Project Address 3615 Chandler Parkway Zip Code 98226Tax Assessor Parcel Number (s) 380316 372176 0000Project Description Residential Multi-Family Planned Development of townhouses and single-family residences on an undeveloped 492,344 sqft (11.303 Acre) lot. Development will include an extension of Sussex Drive.Applicant / Agent ☐ Primary Contact for ApplicantName Tony Freeland, Freeland & Associates, Inc.Mailing Address 220 West Champion Street; Suite 200City Bellingham State WA Zip Code 98226Phone 360-650-1408 Email tfreeland@freelandengineering.comOwner (s) ☐ Applicant ☐ Primary Contact for ApplicantName Dominion Sustainable DevelopmentMailing Address P.O. Box 31548City Bellingham State WA Zip Code 98228Phone 360-319-0898 Email david@ebenal.com

Subject: Plat of Barkley Heights
Response to Request for Improved Information

We have reviewed the requests for improved information dated December 4, 2020 regarding the Plat of Barkley Heights permit submittal. Below is a summary of significant changes.

SHEET CONTENTS: **PRELIMINARY SITE PLAN & ROAD PROFILE**

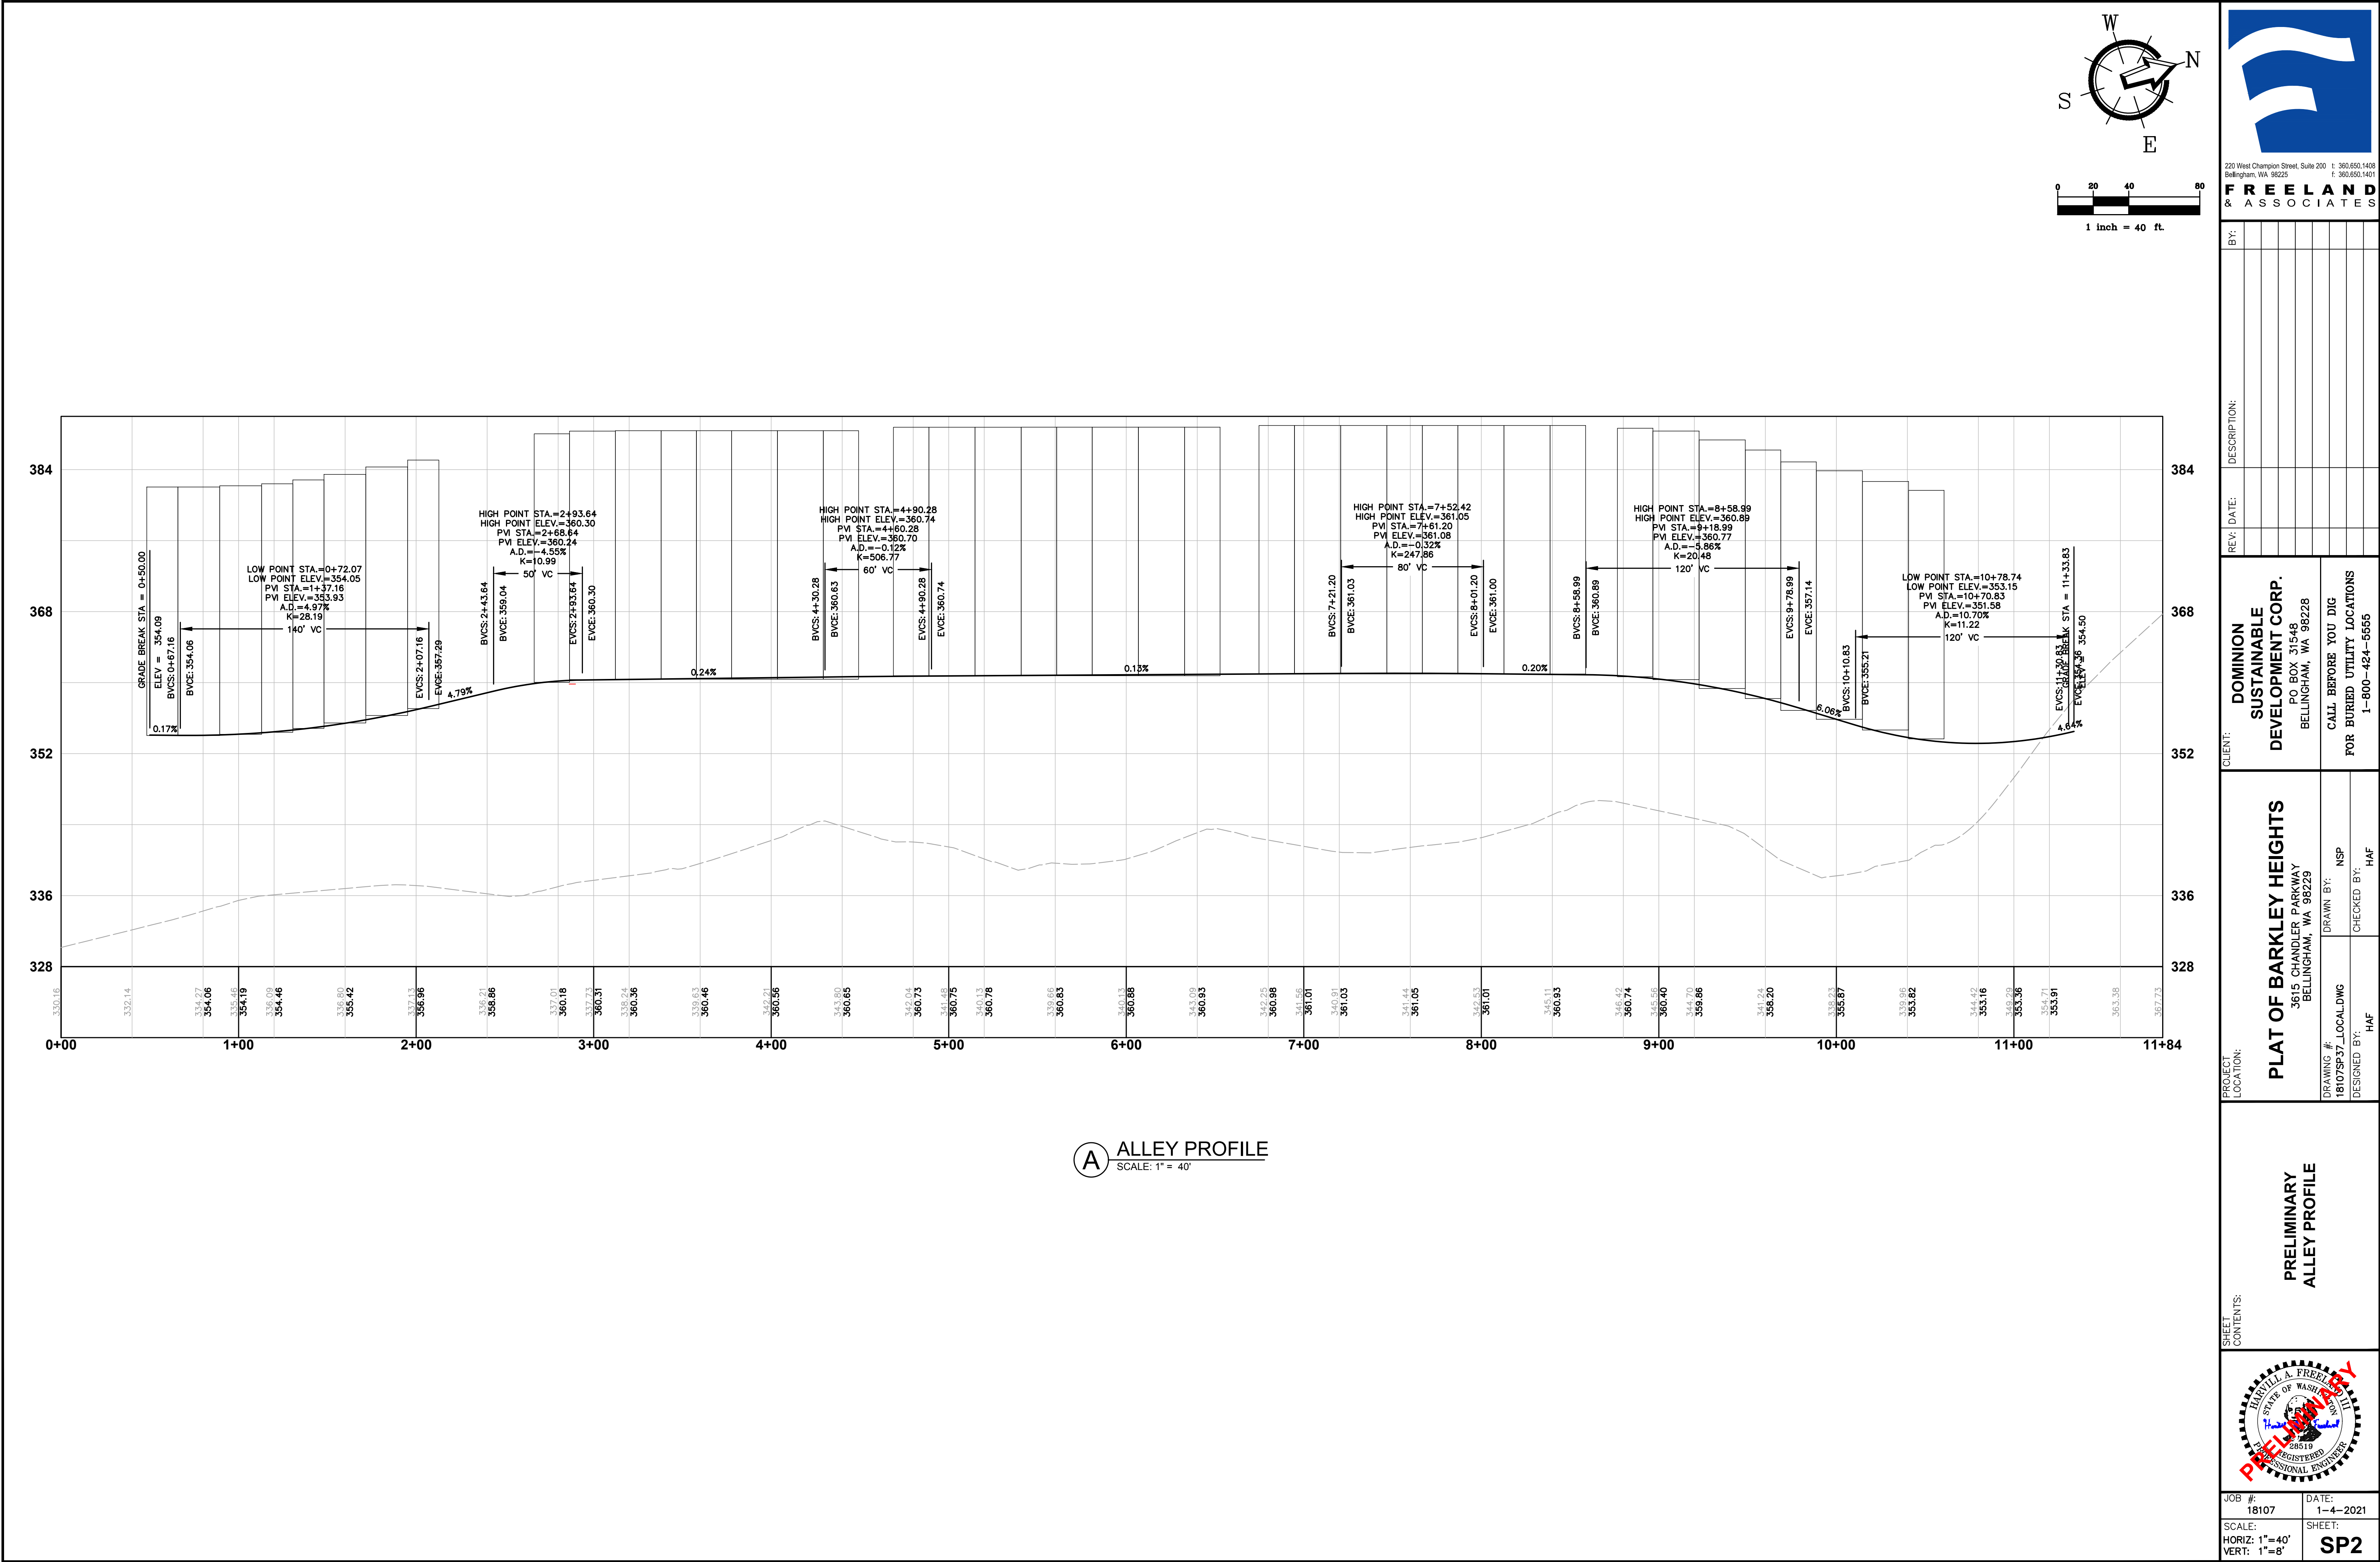
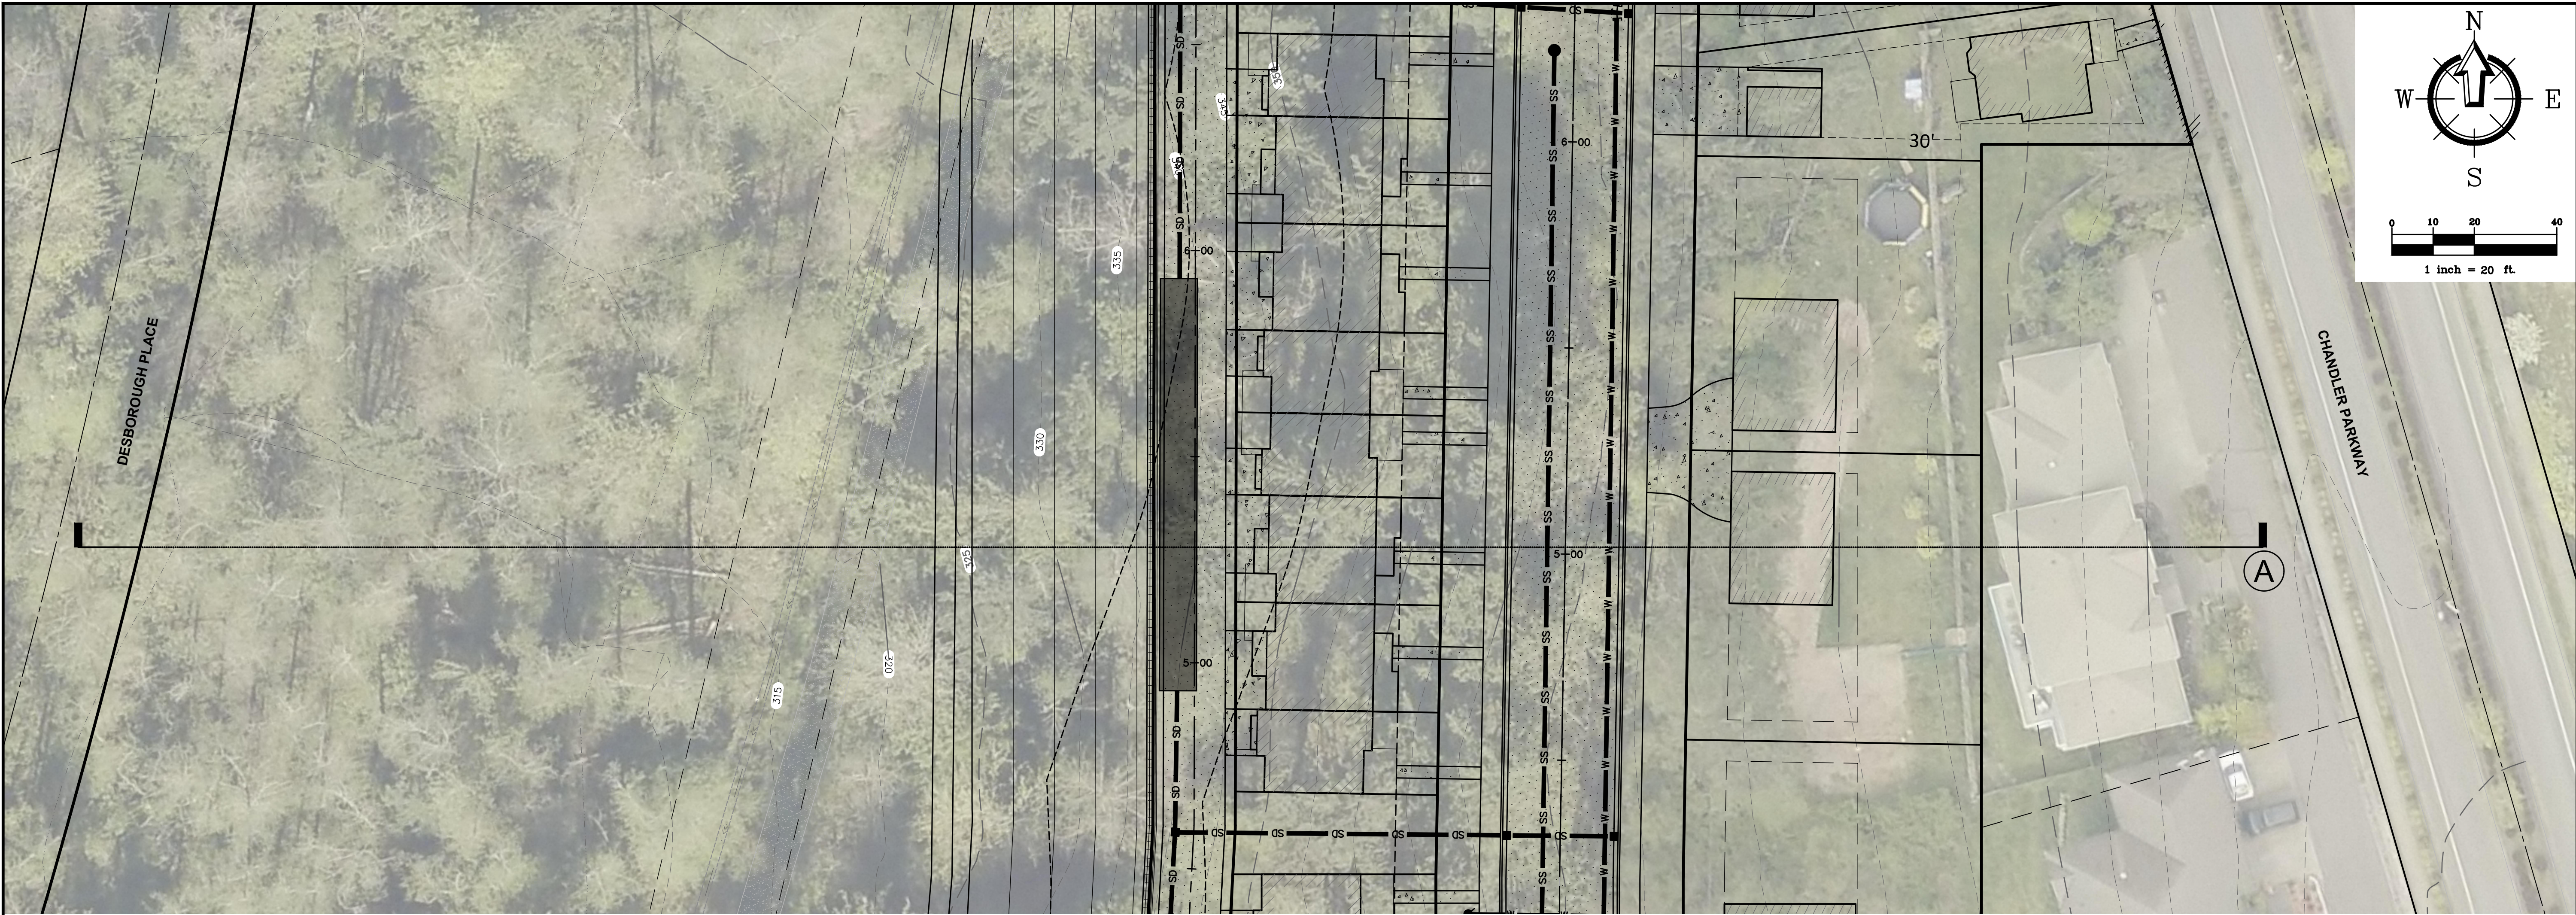
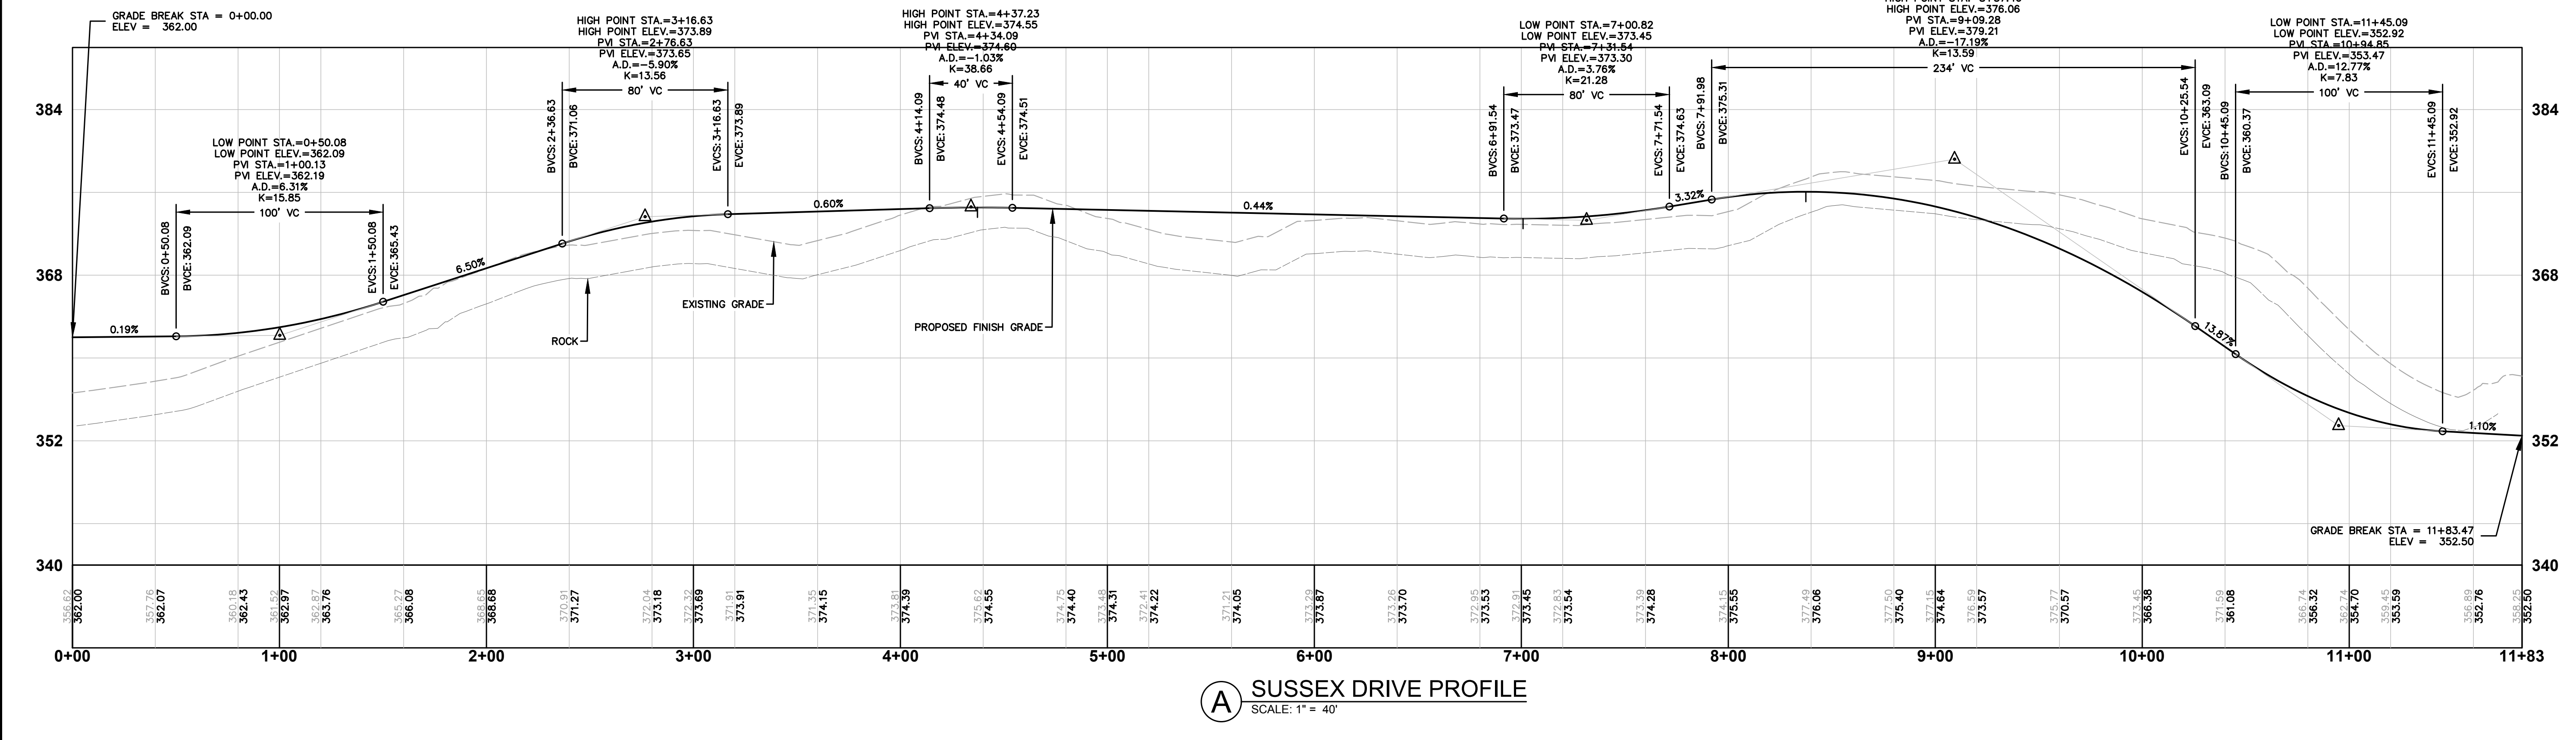
- Show the proposed location of the 30' wide public trail easement to be dedicated to the City as required by the Parks, Recreation, and Open Space chapter of the City's Comprehensive Plan.

Response: This has been noted on the plans.

SHEET CONTENTS: **SITE SECTION CLUSTER LOTS**

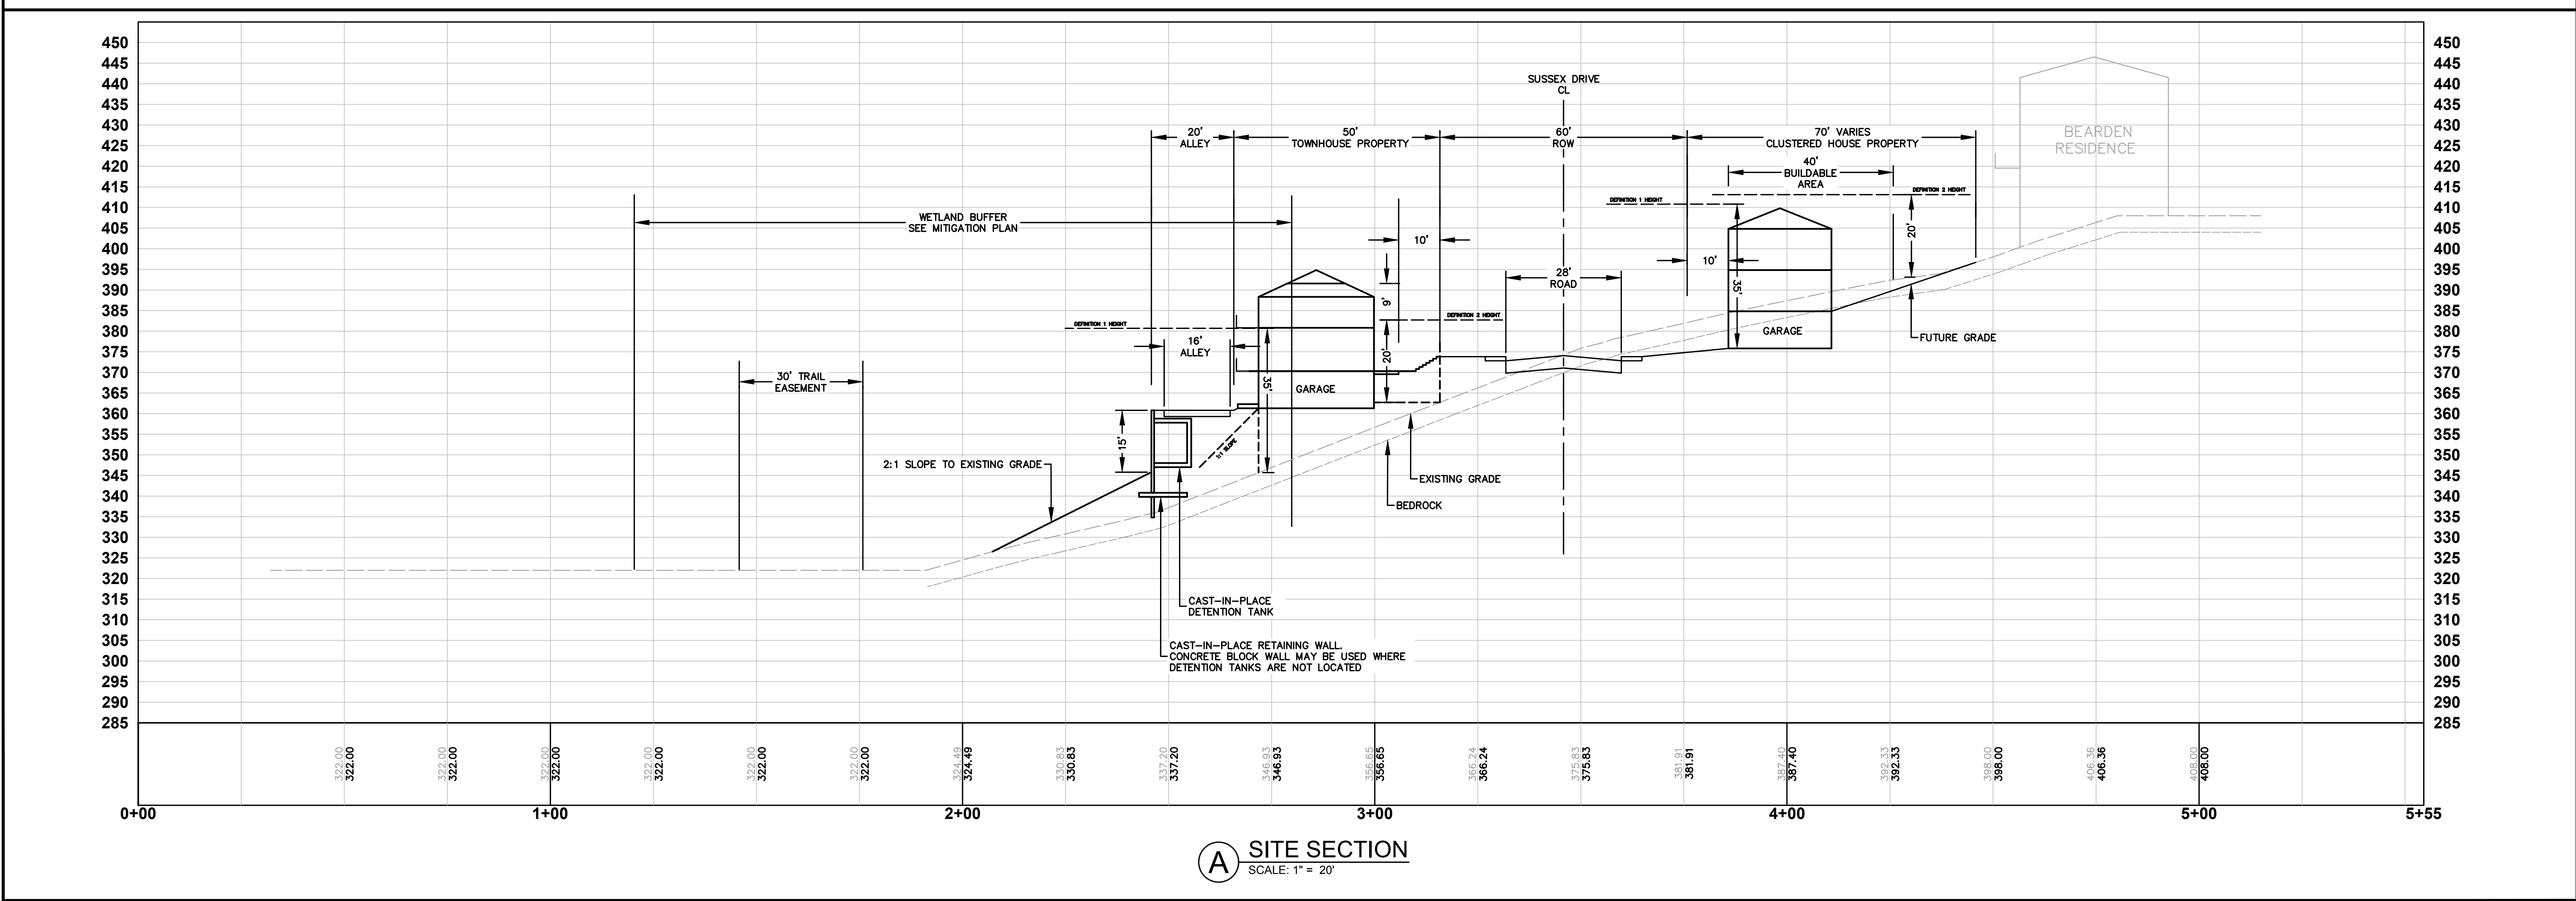
- The proposal did not include any details related to the design of the wall (height, thickness, finish materials, etc.).
- The cross sections suggest the wall is around 30 feet tall;
- The critical area delineation states the wall will be 15 feet tall.

Response: See revised site sections. The wall proposed will typically be 15' high, but a little higher in some cases depending on final grades. Detention vaults will be cast-in-place as part of the wall. Concrete gravity blocks may be used between some cast-in-place sections where detention vaults are not located.
